August 5, 2019

Product Improvement Notice - Reduced weight, tube size on LCI bolt-on hitches

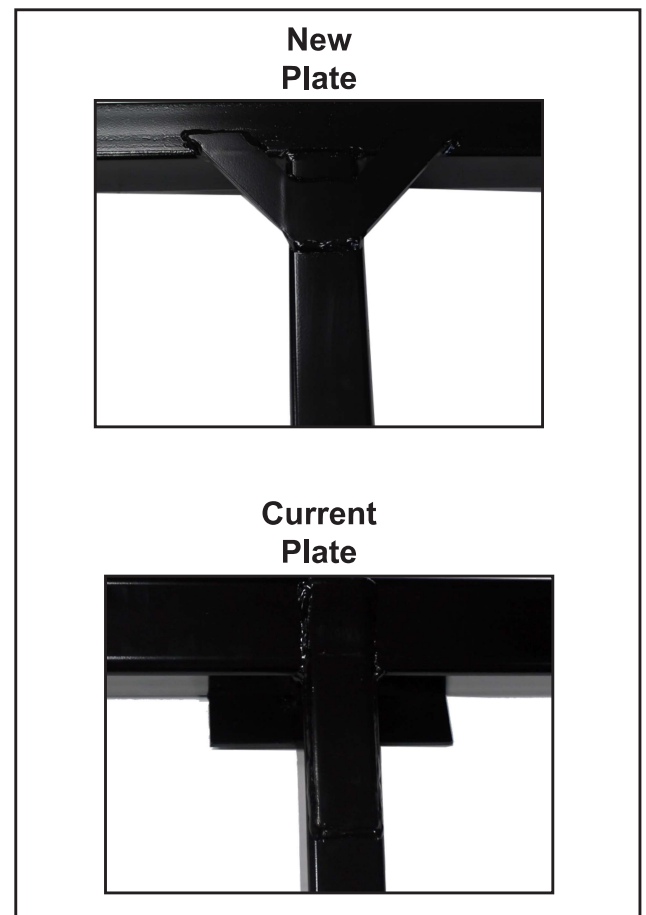
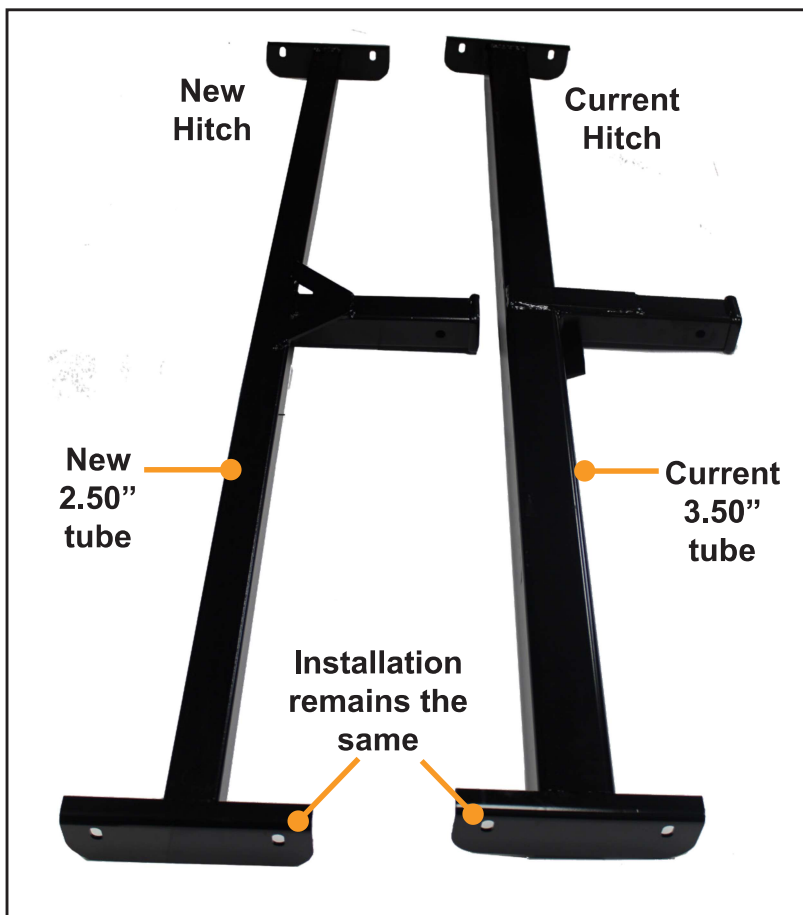
Please be advised we have made an improvement to our LCI bolt-on 2" accessory hitches, which reduces the overall weight of the hitch by approximately 30 pounds, depending on the length of the hitch.

The current hitch was over-designed for the application. The new design features a reduced tube size – from 3.50" to 2.50" – and a new plate on top of the hitch.

The new design passed the same testing requirements as the current hitch design. There is no change in installation for the new hitch. The two hitches mount the same way and the new hitch is wholly interchangeable with the current hitch.

- 75" reduced from 82 lbs to 47 lbs - PN 328676
- 72.5" reduced from 82 lbs to 47 lbs - PN 799970
- 72" reduced from 80 lbs to 46 lbs - PN 430666
- 69" reduced from 77 lbs to 44 lbs - PN 341633
- 69" (with offset receiver) reduced from 77 lbs to 44 lbs – PN 691020
